TECHNICAL SERVICE BULLETIN						
DATE ISSUED	MODEL YEAR(S) AFFECTED		MODEL(S) AFFECTED		TSB #	
2/7/00	1994-2000	S	Spartan Diesel Pushers		191	
BRAND			Түре			
All 🗖 Americ	an Star 🛛 Kountry Star 🗖	Dut	ch Star	All 🗖 T	$T \square F W \square$	
NewAire 🗖 Mountain Aire 🗖 Kountry Aire 🗖			don Aire	C A 🗖 D	P■ DB□	
Air Conditioning & Heating			Electrical Components			
□ Appliances & Accessories			Exterior Components			
Cabinets & Furniture			Interior Components			
Chassis Components			Plumbing & Bath Components			
Construction Components			Windows, Awnings, Vents, & Doors			
DESCRIPTION OF PROBLEM						
RECOMMENDED SOLUTION						
	eded. Cut tubing as indicated in at 5 similar to picture 3 is required of				5460202 and the

Pict. 1

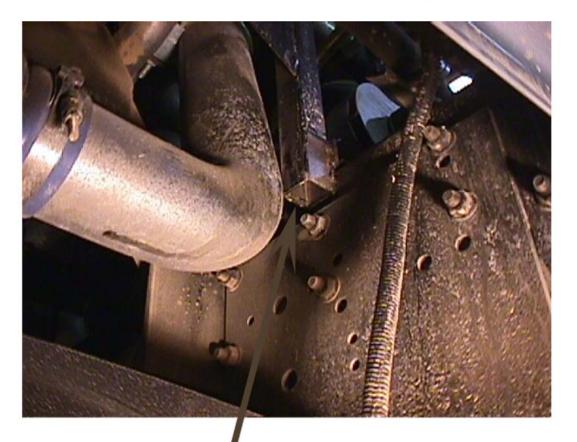
## **Rear Engine Door View**
